GLENORCHY PLANNING AUTHORITY MEETING
AGENDA
WEDNESDAY, 13 DECEMBER 2023

5. PLANNING SCHEME AMENDMENT REQUEST - SITE SPECIFIC CONTROL FOR DRIVE THROUGH FACILITY AND SIGNAGE COMBINED WITH A PLANNING PERMIT APPLICATION FOR A TAKEAWAY FOOD PREMISES WITH A DRIVE THROUGH AND SIGNAGE – 8-10 MAIN ROAD, CLAREMONT, AND COUNCIL LAND AT MAIN ROAD, CLAREMONT

Application No.:	PLAM-23/03
Applicant:	Ratio Consultants obo 8MLC Pty Ltd
Owner:	8-10 Main Road, Claremont (CT 64165/1 & CT 213250/1, PID 5329948): 8MLC Pty Ltd; Main Road, Claremont (CT 136272/1 & PID 2076623): Glenorchy City Council.
Existing Zoning:	Inner Residential Zone
Existing Land Use:	Service Industry (Motor Repairs)
Proposal in Brief:	Planning scheme amendment request for a site-specific qualification (for a drive-through facility and business signage) combined with a planning permit application for a take away food premises with a drive through facility and signage
Representations:	Advertising occurs after amendment is prepared
Recommendation:	Refuse to prepare the planning scheme amendment (if this recommendation is supported the permit application cannot be considered)

Figure 9 – Proposed site plan

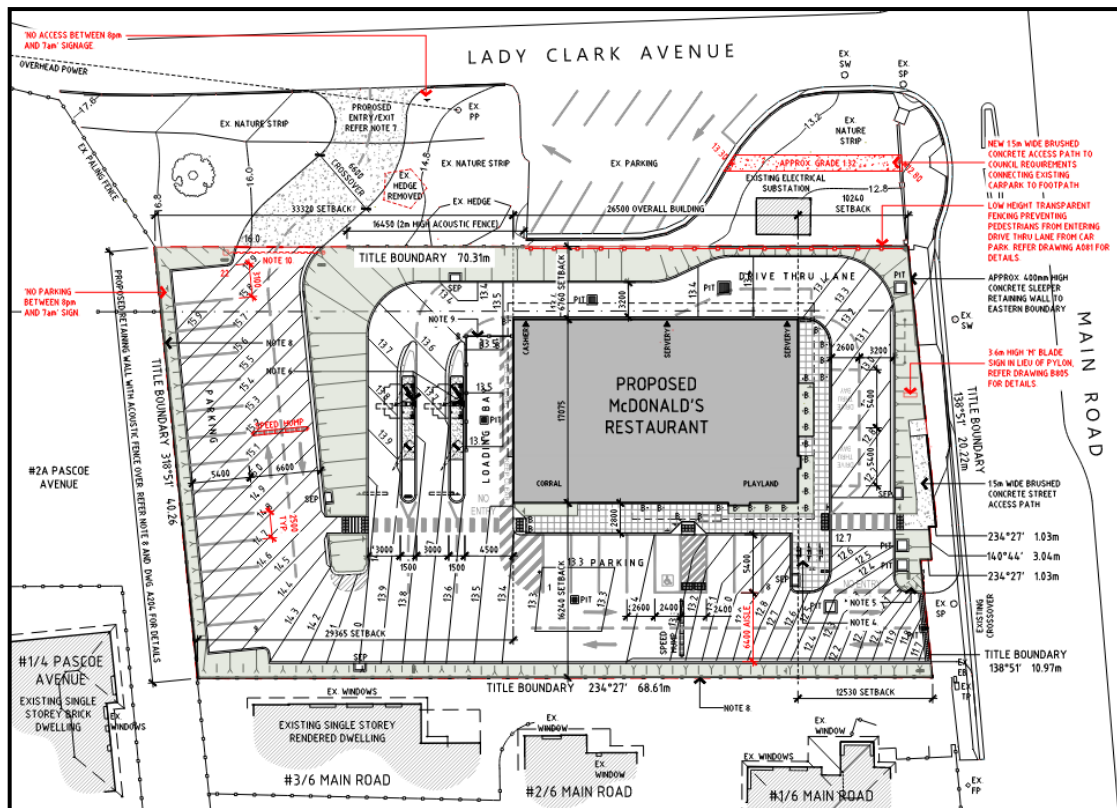
The planning report submitted with the application explains that the proposed maximum number of patrons at any one time would be 75 people. However, the proposed floor plan does not explicitly include a seating layout or provide details about the number of seats proposed in the building.

Figure 11– Section of the acoustic fencing proposed along the south-eastern boundary

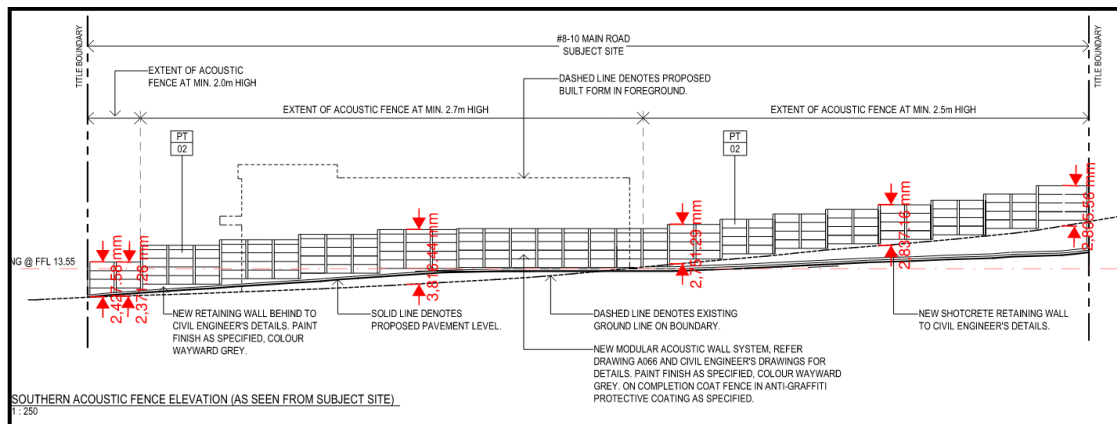
The Applicant's planning report explains that the proposed development comfortably sits within the permissible building envelope, and therefore complies with Clause 9.5.1 (A2). While it is acknowledged the proposed restaurant building would be contained within the permissible building envelope, the proposed acoustic fencing does not meet this requirement. The planning report also describes the acoustic fencing along the south-eastern boundary as having a height ranging between 2m – 2.7m. However, the plans indicate that this is the *minimum* height of the fencing. This has been verified by measuring the height of the proposed fence with the scale indicated on the plans, which shows the fence height along the south-east boundary to be between 2.3m – 3.8m (refer to Figure 11).

The Applicant's planning report does not address the impacts of the fence on the adjoining dwellings.

The proposed fence would be located immediately to the north of the dwellings on the adjoining property along the south-eastern boundary. As discussed above, the dwelling at 3/6 Main Road, Claremont has a setback of 2.5m from this boundary and the setback at 2/6 Main Road would be approximately 5.3m. The details of the location of the habitable rooms and private open space for these dwellings, and the impacts caused due to the length and height of the proposed acoustic fence have not been provided with the planning application. Council's records indicate that the private open space for the dwelling at 3/6 Main Road, immediately abuts the south-eastern boundary of the subject site, the habitable rooms, including openings, are located at 2.5m from this boundary. No shadow analysis diagrams have been provided with the application that enable an assessment of the resulting impacts caused by overshadowing and reduction of sunlight to the habitable rooms and private open space of this dwelling. Given the separation distance of the fence from this dwelling, and orientation to the north of this dwelling, it is considered there would be a considerable reduction in sunlight to the habitable spaces and overshadowing of the private open space of the dwelling at 3/6 Main Road. The impacts on the dwelling at 2/6 Main Road, that is setback slightly further behind at 5.3m, is unclear from the information provided.

Figure 12– Section of the acoustic fencing proposed along the south-western boundary

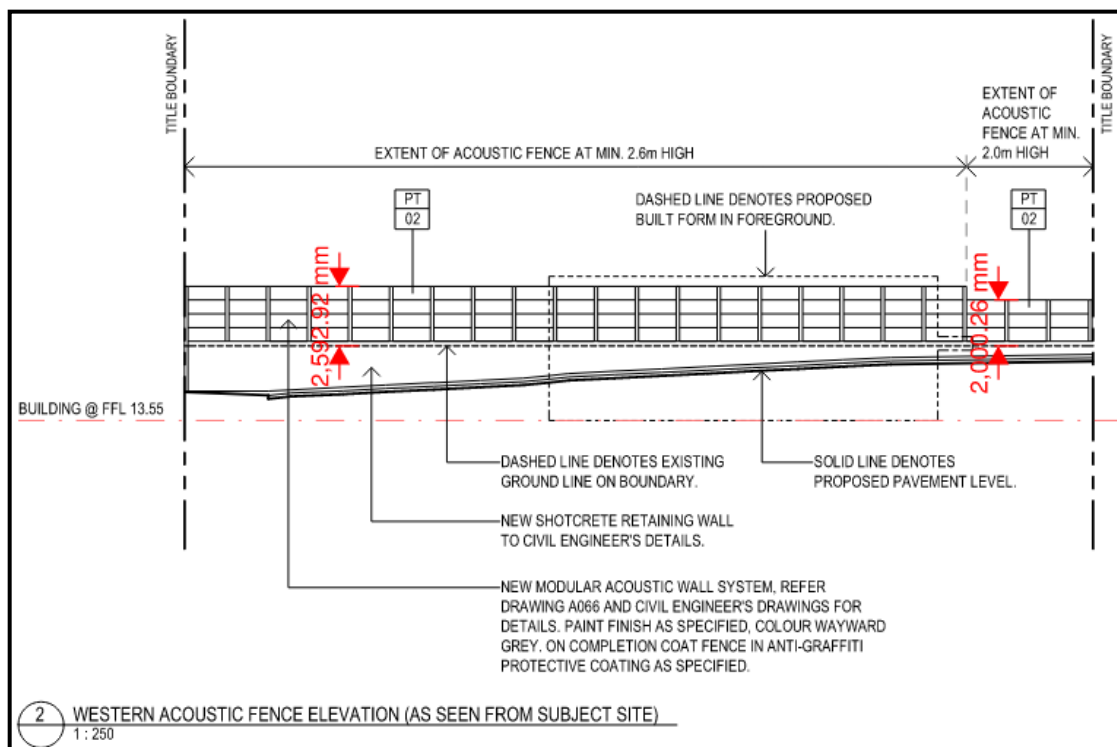
The predominant fencing character in the area is that of low fencing of 1 -1.5m. The fence is not proposed as a result of topography of the site, or to mitigate impacts from Main Road with high traffic volumes, given its location on the side boundary. The proposed height of the fence is derived from the need to provide for attenuation from the noise generated at the subject site due to the proposed use and development. Given the fencing is along the side boundary, the impacts would not be significant for the purpose of this standard as opposed to impacts caused by a tall fence proposed along the front boundary.

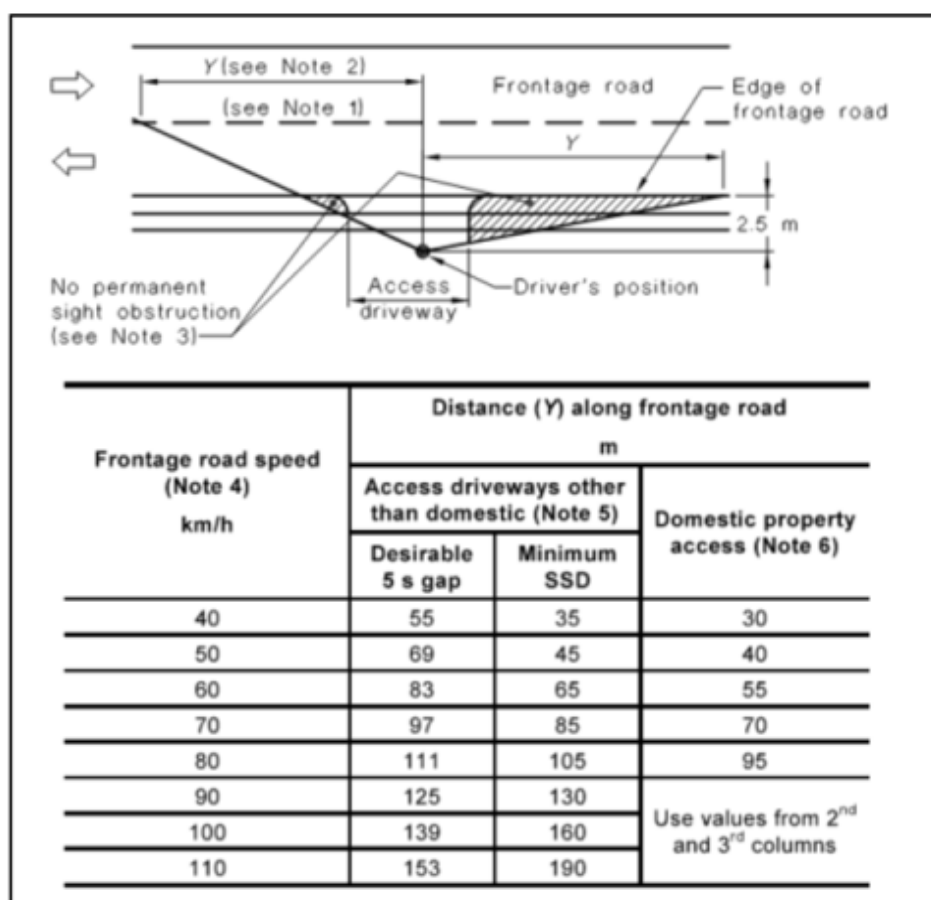
Council's Transport Engineer has reviewed the proposal and provided the following advice (refer to Appendix 4 for full referral).

As outlined in the referral, Council's Traffic Engineer identified a number of concerns with the proposal which are particularly relevant to this standard:

- Insufficient driver sight lines at the driveway crossover on Main Road looking to the right/south.
- Increase in traffic on Lady Clark Avenue due to insufficient road width for vehicles to turn at the proposed driveway concurrently, maintain two-way traffic along the road and still to be determined in the TIA, to safely turn at the junction with Main Road.
- The car park on Council land alongside Lady Clark Avenue does not comply with the standards and has four of the car parks reversing directly onto the road which is unsafe.

Figure 2 – proposed improvement to pedestrian crossing and load bay

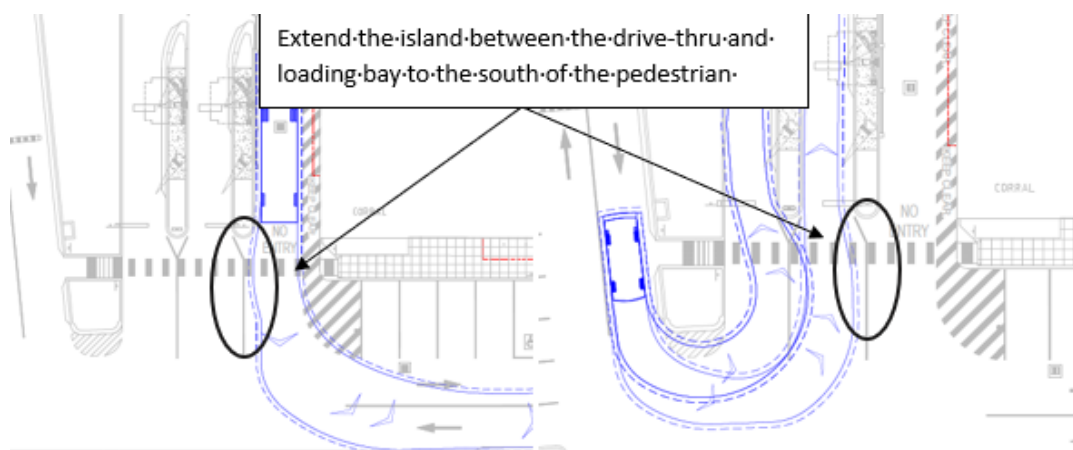
determine if it's safe to cross due to its length. Under this code and C3.5.1 the below is proposed.

To shorten the length of the crossing and assist with drivers going into the drive-thru not crossing over into the loading bay, it is proposed that the existing island between the drive-thru and the loading bay is extended to the south of the pedestrian island indicated below. The swept path movements show that this is possible with possibly a mountable kerb on the loading zone side. A condition will be placed on the permit for this.

Figure 5 – Proposed Traffic to the Site from the Development

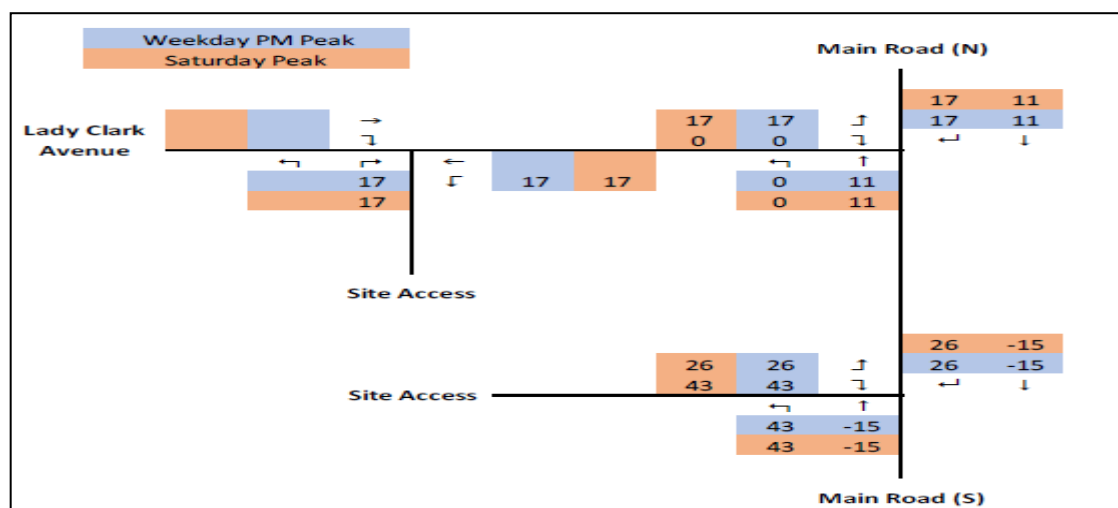
The traffic split in the TIA is assumed on Lady Clark Ave to be 20% in from the north and 20% heading out to the north. Main Road driveway traffic in is 30% from the north and 50% from the south and traffic out is 30% to the north and 50% to the south. The split in traffic seems reasonable as 60% of the traffic is via the drive-thru, and location of parking being 8 car parking spaces located out the front entrance near Main Road and another 13 to 14 along the western boundary close to Lady Clark Avenue.

The split in traffic is shown below and the post development peak hour traffic volumes based on this split in traffic of 170 vehicles in peak hour. The pm peak 4pm to 5pm and Saturday peak 11.30am to 12.30pm, was assessed in the TIA and not the AM peak 8am to 9am, as less than pm peak.

In Lady Clark Avenue 17 vehicles will be entering and 17 vehicles will be leaving per hour due to the development. Current traffic volumes in TIA on Lady Clark Ave are a maximum of 6 vehicles entering and 6 vehicles leaving per hour. This means the peak traffic will be increasing by 34 vehicles per hour to around 46 vehicles. This equates to a daily traffic volume of approximately 460 vehicles per day.

Figure 6 – Lady Clark Avenue layout and swept paths

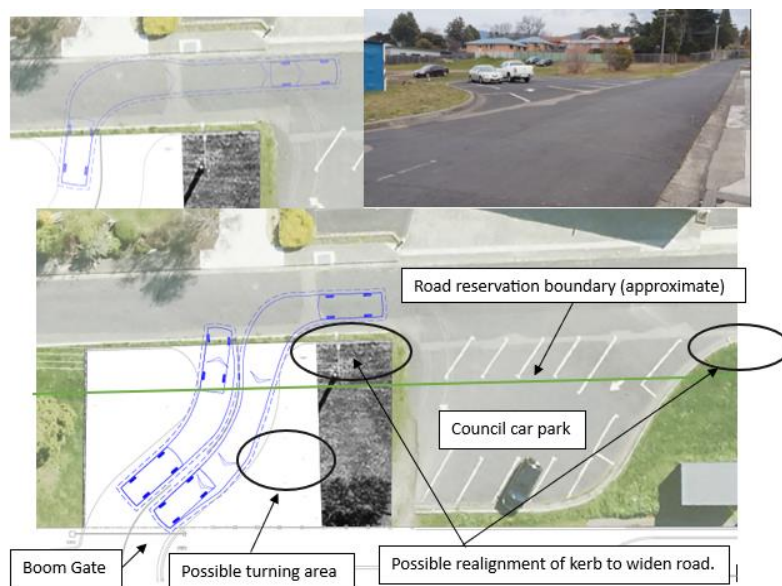
The swept paths of vehicles in the TIA at the driveway crossover onto Main Road are acceptable. The swept paths of vehicles at the driveway crossover onto Lady Clark Avenue, as stated in the TIA, show that access is constrained with a narrow carriageway requiring the outbound vehicles to prop in the site access while an entering vehicle makes its movement. The swept path also shows that parking is required to be banned opposite the driveway and to the east of the driveway.

The swept paths are shown below, along with details on the road, boom gate, and photo. The boom gate to the driveway is located about 14m from the road, and a sign will be placed at the driveway entrance.

To allow for a vehicle to be able to enter and exit the driveway concurrently, it is proposed that the road is widened to a minimum of 6.9m. The road may also need to be widened at the Main Road end to allow for vehicles to turn safely and at the Council car park. A condition will be placed on the permit to widen the road to allow vehicles at the driveway and junction to safely turn which will include swept paths at the junction not provided.

LADY CLARK AVENUE – RECOMMENDATION

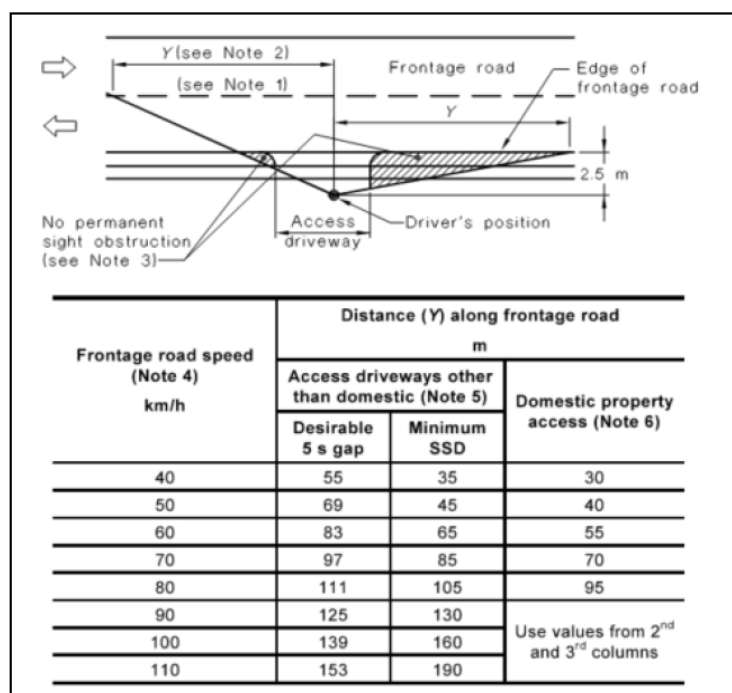
Sight lines is considered appropriate due to the low volume and speed of vehicles on Lady Clark Avenue. However, an assessment should be undertaken like the below for Main Road as part of the TIA. A condition will be placed on the permit for this to occur and if sight lines are not met, then there is space for the location of driveway crossover onto the road to be modified due to 14m between the road and entrance to car park.

The requirement to widen the road, redo the car park to the standards with no parking reversing onto the road and put in a turning area before the boom gate is made by the Road Authority due to increase in the traffic from the development and condition placed on the permit to undertake.

Sight lines at the junction with Main Road and driveway should be assessed by the developer and parking prohibited if required in consultation with Council.
